Subject: Oconee Nuclear Station  
Docket Nos. 50-270  
Additional Information Related to the NRC's  
Interim Report on the Oconee Emergency Power  
System

**Comments on the NRC Interim Report  
for the Oconee Emergency Electrical System**

Figure 1

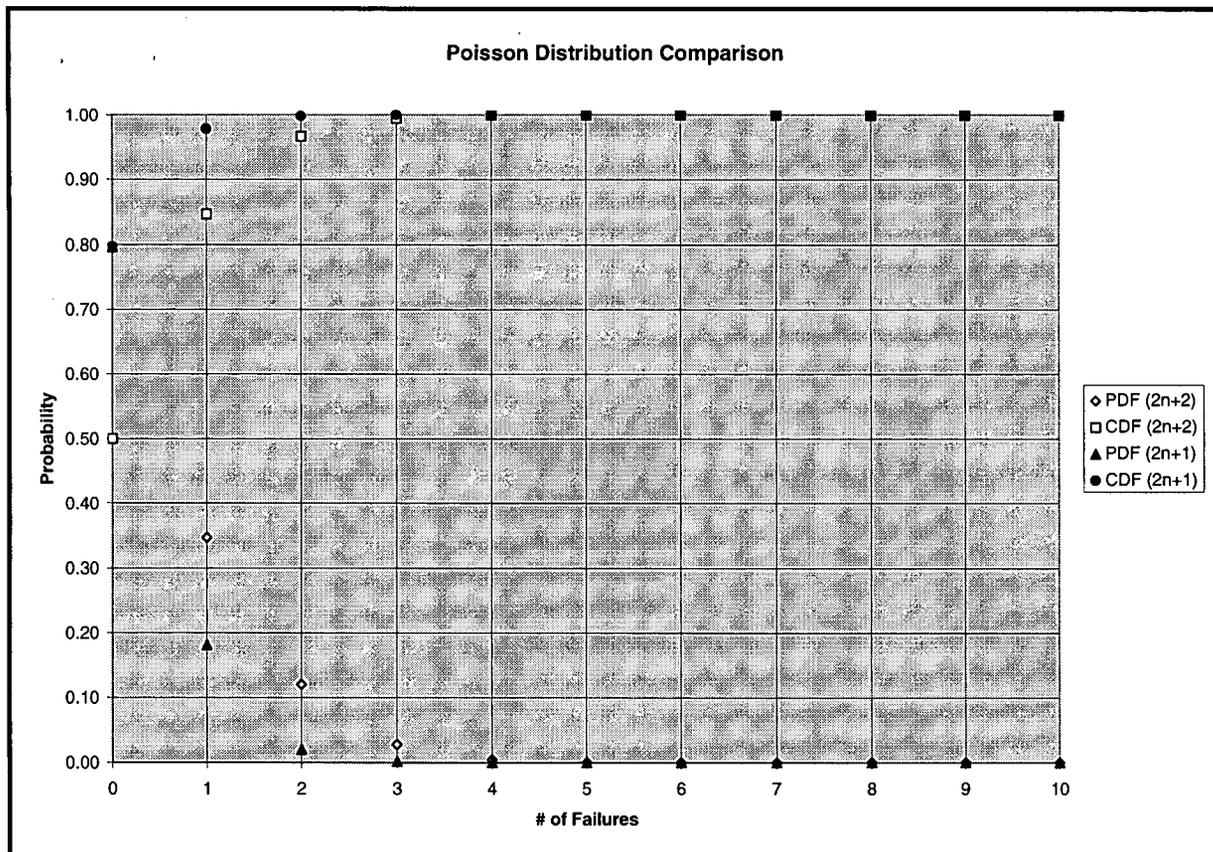
The method of estimation proposed by the Staff is derived from considerations for a conservative upper confidence limit of a Poisson distribution ( $2n+2$  degrees of freedom for the upper confidence limit and  $2n$  for the lower confidence limit). As such, it should be remembered that the confidence value is derived on the number of failures (a discrete random variable) not the failure rate. The most appropriate use for this limit seems to be as an estimator of the range on the number of failures in future observations of the process. To refer to the failure rate estimate derived from the upper confidence limit on the number of failures as a confidence limit on the failure rate is questionable. Figure 1 illustrates the probability density functions and the cumulative distribution functions for Poisson distributions based on failure rates calculated by the Staff's suggested method and the method used by Duke. As seen and as expected, if the actual failure rate is as estimated with the Staff's approach ( $2n+2$  degrees of freedom), 50% of the samples contain 0 failures and 50% contain 1 or more failures. On the other hand, using Duke's approach ( $2n+1$  degrees of freedom), 80% of the samples contain 0 failures and 20% contain 1 or more failures. Both results are reasonable and one is more conservative in characterizing the failure rate. To relate this concept to the specific components modeled in the Keowee PRA, it implies that with zero failures in the past 10 years, the Staff's suggested model would estimate a 50% chance of 0 failures in future observations (10 year periods) while the method used in the Keowee PRA would imply that there is an 80% likelihood of seeing 0 failures (20% chance of one or more failures). Both estimates are reasonable and one should not be characterized as incorrect.

Because distributions such as the Binomial and the Poisson are discrete, it is not possible to establish upper and lower confidence limits that provide exactly the confidence level desired. A desired condition for an upper confidence limit is  $P(\lambda > \lambda_{upper}) = 0.05$  for all  $\lambda$ . The limit, like the random variable, can take on only integer values. The equality can not be made true for all possible values of  $\lambda$ . It is customary to adopt a conservative definition by requiring instead that  $P(\lambda \geq \lambda_{upper}) \leq 0.05$ . A similar inequality is established for the lower limit. As a result, limits for a 90% confidence interval, for example, actually provide "at least" 90% confidence. The upper and lower limits that result can be evaluated from chi-square distributions where the degrees of freedom for the upper and lower limits are  $2n+2$  and  $2n$  respectively. The upper and lower limits derived in this manner are for the Poisson random variable which is the number of observed failures. When these values are modified and applied as confidence intervals on the underlying failure rate (a continuous variable), the real meaning of these values is distorted. It is observed that as the confidence interval is shrunk (the upper and lower limits both approaching the median) the limits do not collapse to a single point due to the differing degrees of freedom. This residual

interval results from the discreteness of the original distribution and the inability to satisfy the equality in determining the confidence limits. The method used in the Keowee PRA selects a point within this interval by performing the median calculation using a degrees of freedom that is the average of the values for the upper and lower limits ( $2n+1 = [2n+2 + 2n]/2$ ). This can be considered to be an approximate numerical correction for the discreteness of the data.
